**City of Ketchum
Planning & Building**

**STAFF REPORT
KETCHUM PLANNING AND ZONING COMMISSION
MARCH 5, 2026 MEETING**

- PROJECT:** 233 Parkway Variance
- FILE NUMBER:** P25-059
- REPRESENTATIVE:** Darshan Amrit, A2 Studio (Architect)
- OWNER:** Jeff and Michelle Bruner
- REQUEST:** Variance to enlarge and extend an existing nonconforming garage into the front setback area and outside of the platted building envelope of the subject property on Parkway Drive.
- LOCATION:** 233 Parkway Drive
- ZONING:** Limited Residential (LR)
- OVERLAY:** Floodplain
- NOTICE:** A public meeting notice for the project was mailed to all owners of property within 300 feet of the project site and all political subdivisions on February 11, 2026. The notice was published in the Idaho Mountain Express on February 11, 2026. A notice was posted on the city's website on February 11, 2026, and posted on the project site on February 26, 2026.
- REVIEWERS:** Paige Nied – Associate Planner

Figure 1 Existing non-conforming portion in question (head-on view)

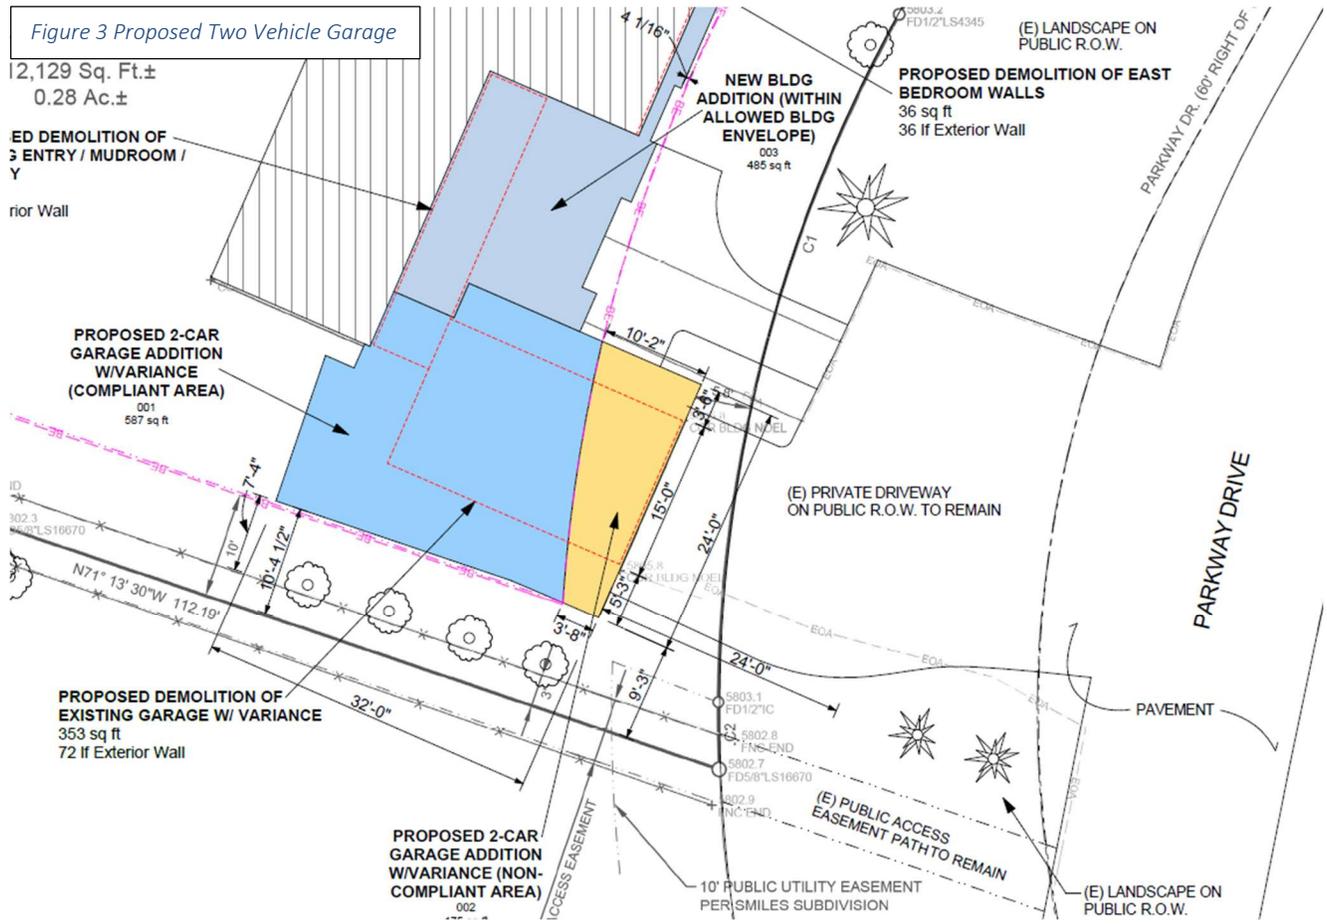
The applicant submitted a Variance Application for approval to demolish the existing nonconforming single vehicle garage attached to the residence and increase the degree of nonconformity by constructing a two-vehicle garage in its place that further encroaches into the minimum required front setback area and marginally into the side setback. The subject property is located at 233 Parkway Drive and is within the Limited Residential (LR) Zone District. The LR zone has a minimum front setback requirement of 15 feet and side setback of 1 foot for every 2 feet in building height. The existing encroachment is a 15-foot span of the building that extends into the front setback by 9 feet 5 inches at the north end and 5 feet 6 inches at the south end. The proposed encroachment is a roughly 24-foot span of the building that extends into the front setback by 10 feet 2 inches at the north end and 3 feet 8 inches at the south end. See Figure 1 for a head-on view of the existing encroachment and see Figure

2 for an aerial view. The garage would encroach approximately 3 ½ inches into the side setback area. The existing and proposed encroachment extends outside of the platted building envelope on the property.

Since the residence was constructed in 1972, there have been various additions to the structure by previous owners. The existing 2,997 square foot single-story residence is considered nonconforming due to the front portion of the attached garage encroaching into the setback area.

G-002

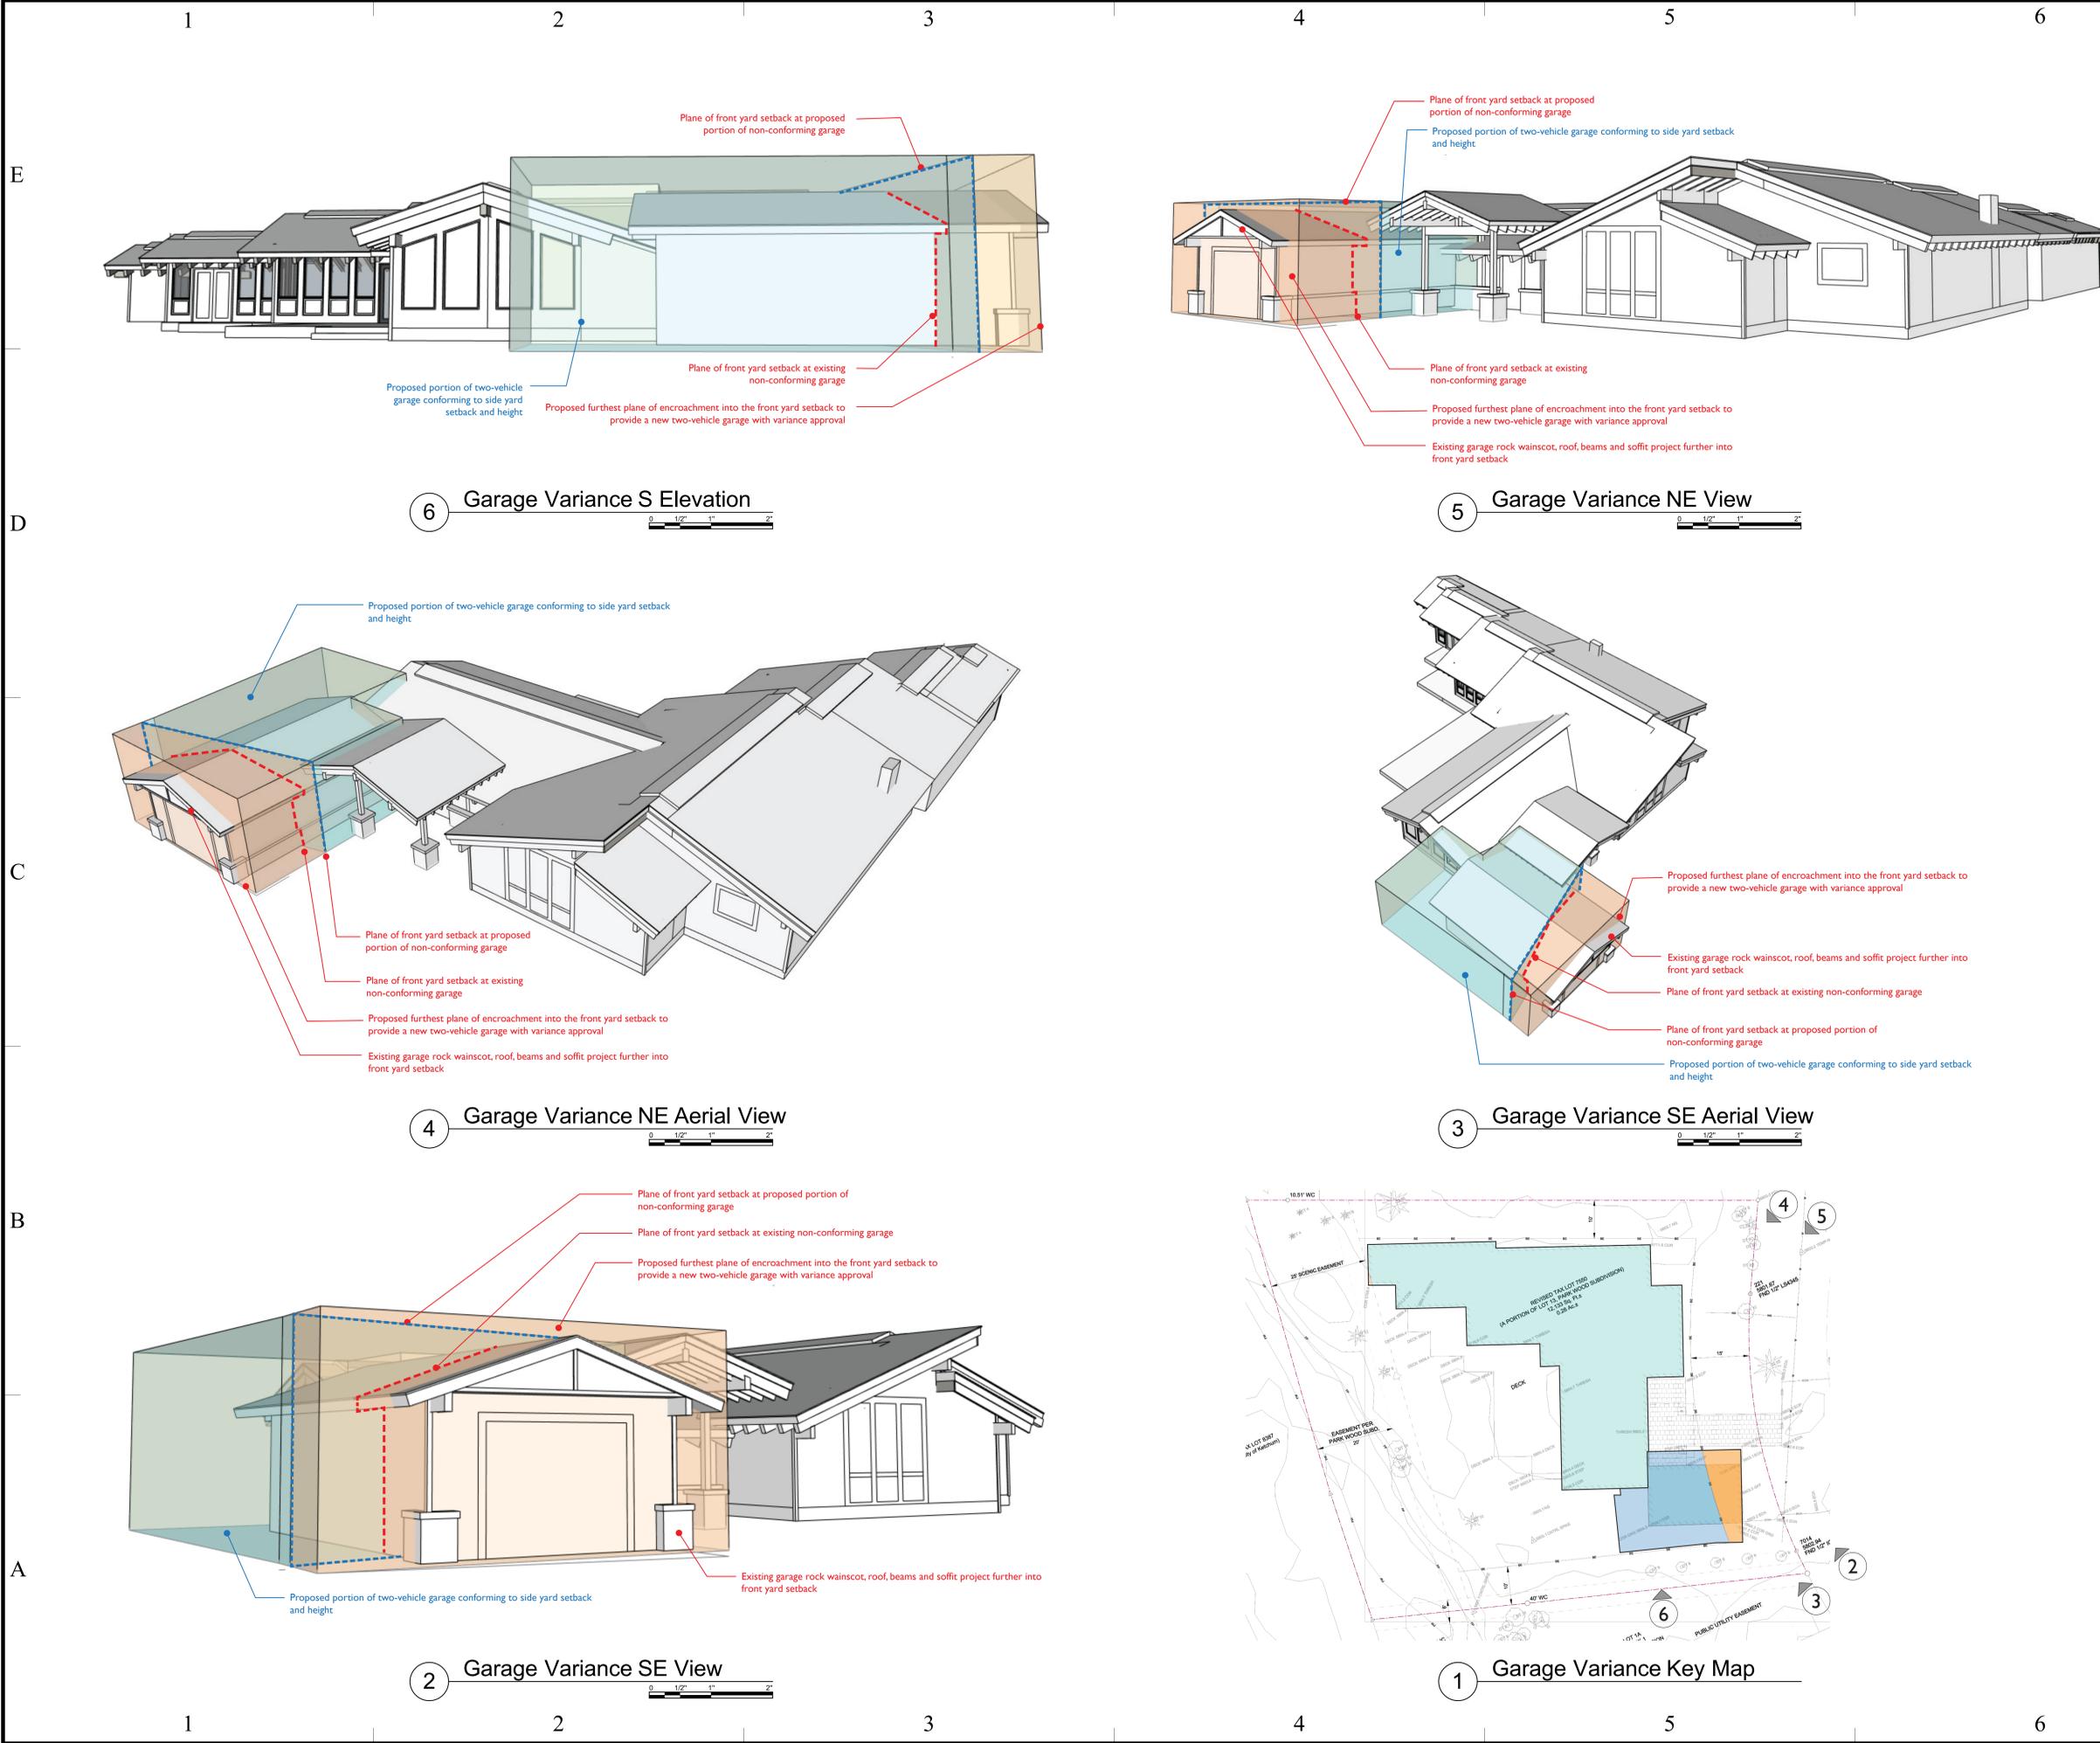
Staff Analysis: As outlined on Sheet G-002 in the application materials included as Attachment A, the applicant team developed several alternative studies to provide a two-vehicle garage and determined that the proposed design of the two-vehicle garage is the least impactful to the existing structure and surrounding neighborhood of options A-E they explored. While the proposed garage would increase the degree of nonconformity in regard to the front setback, it would also decrease the degree of nonconformity as it would also bring the residence into conformance with off-street parking requirements.
